**SERVICE BULLETIN 36
(Reprint)**

RE: Lethal Weapon 3 Flippers

REQ.	NEXT ASSEM.	DWN.	DATE	TITLE
MAT.		CH'KD.	SCALE	<i>FLIPPER ADJ. / LETHAL WEAPON</i>
H.T.				<i>3</i>
FIN.				PART NO.

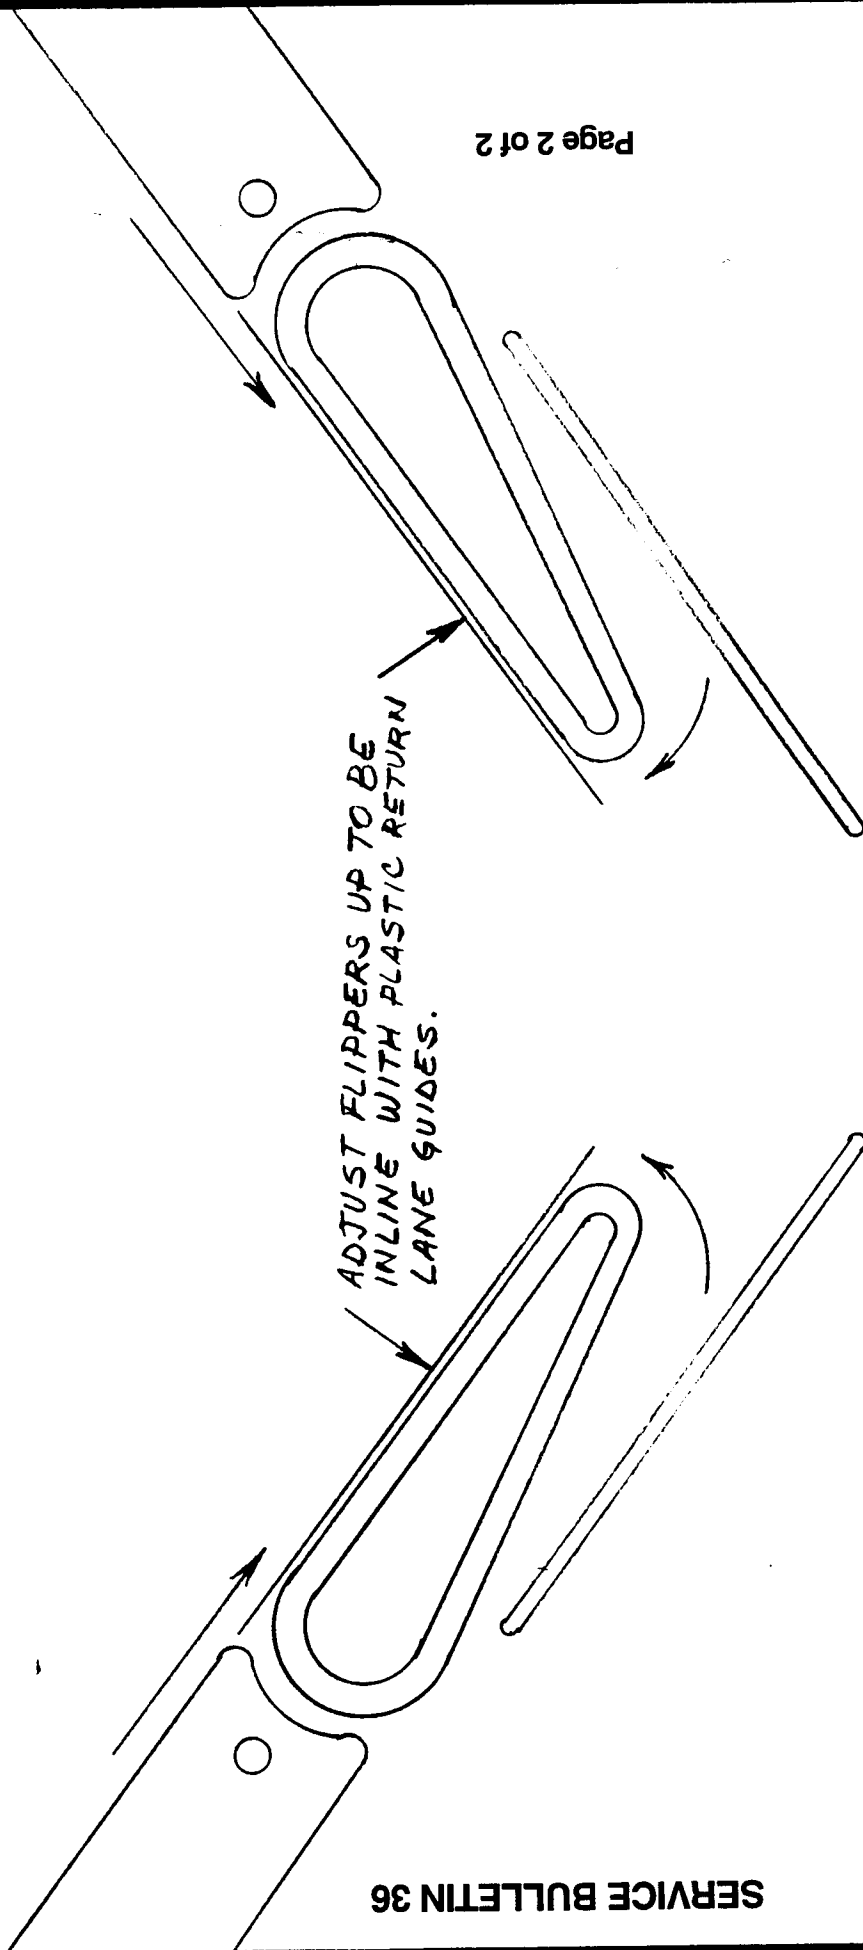
Symtom: The flippers appear weak on some Lethal Weapon 3 games, making it difficult to complete the ramp shot(s).

Cause: The flipper bat is not aligned properly with respect to the return lane guides. The bats are probably pointed too low, resulting in an inadequate striking angle on the ball.

Solution: Loosen the socket head screw connecting the Plunger Link & Pawl Assembly to the bat and align each flipper with respect to the plastic return lane guides. (See attached drawing).

*ADJUST FLIPPERS UP TO BE
INLINE WITH PLASTIC RETURN
LANE GUIDES.*
